**TECHNICAL NOTE – 05**

**JERSEY FARM TRAFFIC AND TRANSPORT TECHNICAL NOTE**

**JERSEY FARM, CRAWLEY, WEST SUSSEX**

# JERSEY FARM DEVELOPMENT CRAWLEY: HIGHWAY IMPROVEMENTS

Drg: 21071 SK210923.2 Rev -

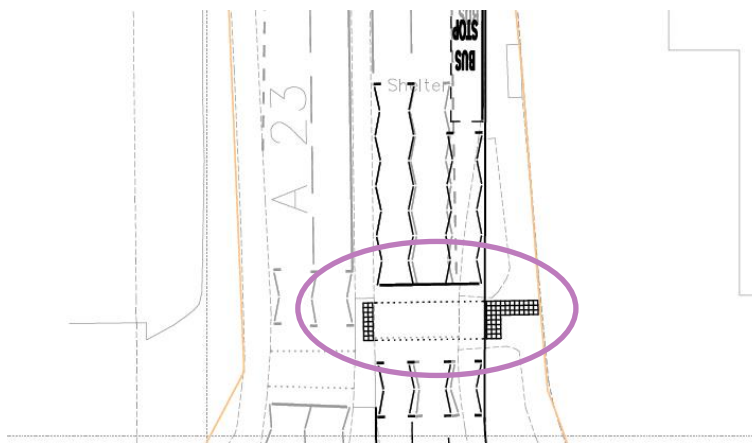
2.2 After due and careful consideration, the audit team have been unable to identify any areas of concern regarding highway road safety associated with the information provided on this drawing.

RSA problem	RSA recommendation	Design organisation response	Overseeing Organisation response	Agreed RSA action
<p>21071 SK210923.2 - Proposed Site Access 2.2 After due and careful consideration, the audit team have been unable to identify any areas of concern regarding highway road safety associated with the information provided on this drawing</p>	<p>None.</p>	<p>The RSA was undertaken based on Connect sketch drawing 21071 SK210923.2. As the RSA found no problems, the scheme drawing has been finalised as drawing 21071 – 010.</p>		<p>Scheme drawing finalised as drawing 21071 – 010.</p>
<p>21071 SK210831.1 – Fleming Way Roundabout 2.3 Problem 1 There is the potential for the drivers of vehicles approaching the crossing to be unaware of the signal operation should a high sided vehicle be located to either side in lanes 1 and 3. This in turn could resulting in failure to conform and an increased risk of collision with users of the crossing</p>	<p>It is recommended that as part of the detailed design secondary signal poles are located such that signal heads can be viewed from all lanes, the use of double height signal heads may also be beneficial</p>	<p>Drawing will be updated to show location of new secondary signal heads mounted on double height poles.</p>		<p>Scheme drawing to be updated and finalised as drawing 21071 – 011.</p>

Drg: 21071 SK210831.1 Rev -

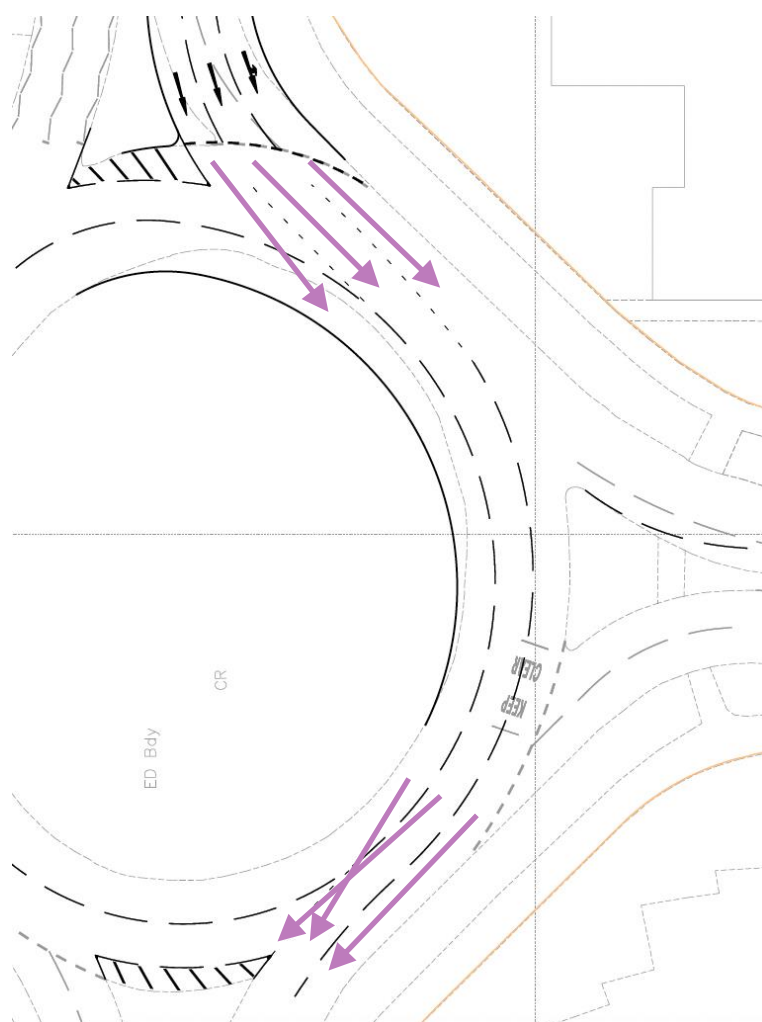
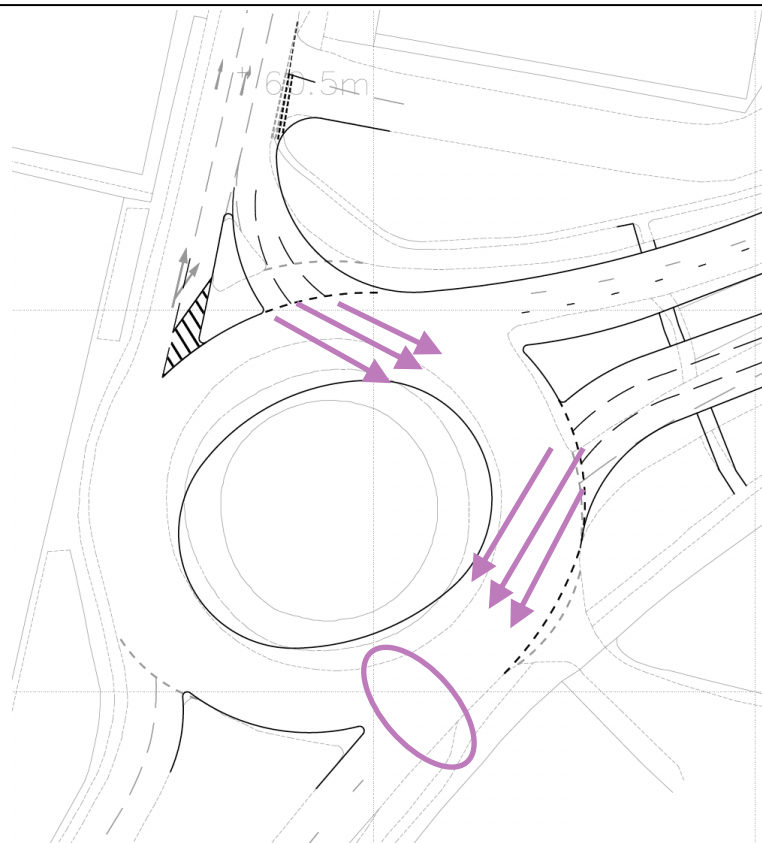
2.3 Problem 1

There is the potential for the drivers of vehicles approaching the crossing to be unaware of the signal operation should a high sided vehicle be located to either side in lanes 1 and 3. This in turn could resulting in failure to conform and an increased risk of collision with users of the crossing

It is recommended that as part of the detailed design secondary signal poles are located such that signal heads can be viewed from all lanes, the use of double height signal heads may also be beneficial

2.4 Problem 2

It is recommended that the arrows on the approach to the give way from the north are supplemented with route destination marking in the form of route designation numbers and directional signing is provided to provide appropriate driver information in terms of lane choice for destinations. Lane 1 should be marked for left turn only. There appears to be sufficient space within the circulatory carriageway to allow for lane widths to be adjusted and spiral markings introduced which would guide drivers to appropriate exit points.

RSA problem	RSA recommendation	Design organisation response	Overseeing Organisation response	Agreed RSA action
<p>21071 SK210831.1 – Fleming Way Roundabout 2.4 Problem 2 Southbound approach to roundabout give way. There is the potential for drivers seeking to travel north to south through the roundabout to choose any of the three approach lanes to undertake the desired manoeuvre as indicated by the lane markings. Realistically lane 3 continues round the circulatory carriageway rather than allowing the movement identified to occur leading to the potential for inappropriate lane changing and an increased risk of side impact collisions on the circulatory carriageway.</p>	<p>It is recommended that the arrows on the approach to the give way from the north are supplemented with route destination marking in the form of route designation numbers and directional signing is provided to provide appropriate driver information in terms of lane choice for destinations. Lane 1 should be marked for left turn only. There appears to be sufficient space within the circulatory carriageway to allow for lane widths to be adjusted and spiral markings introduced which would guide drivers to appropriate exit points.</p>	<p>Lane markings will be supplemented with route destinations as suggested, however, the predominant traffic flow on this approach is straight ahead to the A23 south, so the left lane will be marked for both left and ahead, which means there is no need for spiral lane markings on the circulatory carriageway.</p>		<p>Scheme drawing to be updated and finalised as drawing 21071 – 011.</p>

Drg: 21071 SK210923.1 Rev -

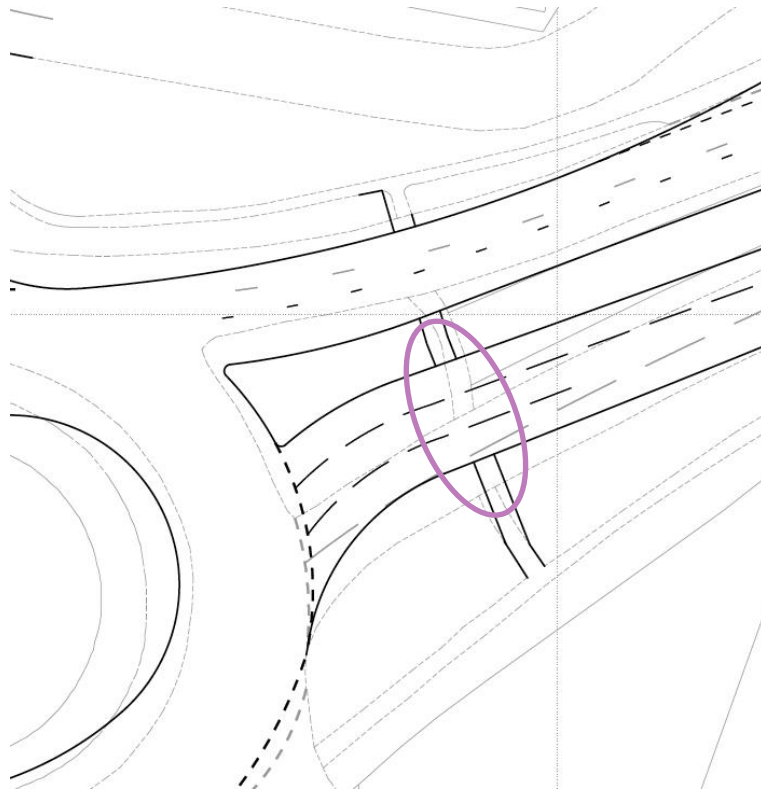
## 2.5 Problem 3

It is recommended that arrows and route destination marking in the form of route designation numbers and directional signing are provided for all approaches. Lane 1 for each approach being marked marked for left turn only. Similarly, to Fleming Way Roundabout there appears to be sufficient space within the circulatory carriageway to allow for lane widths to be adjusted and spiral markings introduced which would guide drivers to appropriate exit points.

#### 2.6 Problem 4

Location: Lowfield Heath Roundabout: Westbound uncontrolled crossing

RSA problem	RSA recommendation	Design organisation response	Overseeing Organisation response	Agreed RSA action
<p>driver confusion as to appropriate lane selection and as such increased the potential for side impact type collisions on the circulatory carriageway as drivers seek to take the desired exit. In this case the circulatory carriageway is not marked which is likely to exacerbate the confusion and increase potential for collisions.</p>	<p>be sufficient space within the circulatory carriageway to allow for lane widths to be adjusted and spiral markings introduced which would guide drivers to appropriate exit points</p>			
<p>21071 SK210923.1 – Lowfield Heath Roundabout 2.6 Problem 4 Westbound uncontrolled crossing. The proposals lead to the widening of the west bound approach to the roundabout to three lanes at the uncontrolled pedestrian crossing point. It is virtually impossible for pedestrians, particularly the elderly, young and disabled to cross three lanes of live traffic in a safe manner. If pedestrians seek to cross between stationary or slow-moving traffic driver visibility of the crossing movement and also pedestrian visibility of the</p>	<p>It is recommended that either the crossing location is removed, and pedestrians directed to the other side of the roundabout where maximum crossing distances are over two lanes or that a signal-controlled pedestrian crossing is provided.</p>	<p>The crossing location will be removed, and relocated on the southern arm of the junction as suggested.</p>		<p>Scheme drawing to be updated and finalised as drawing 21071 – 012.</p>

RSA problem	RSA recommendation	Design organisation response	Overseeing Organisation response	Agreed RSA action
oncoming vehicles is compromised leading to an increased risk of vehicle pedestrian collisions
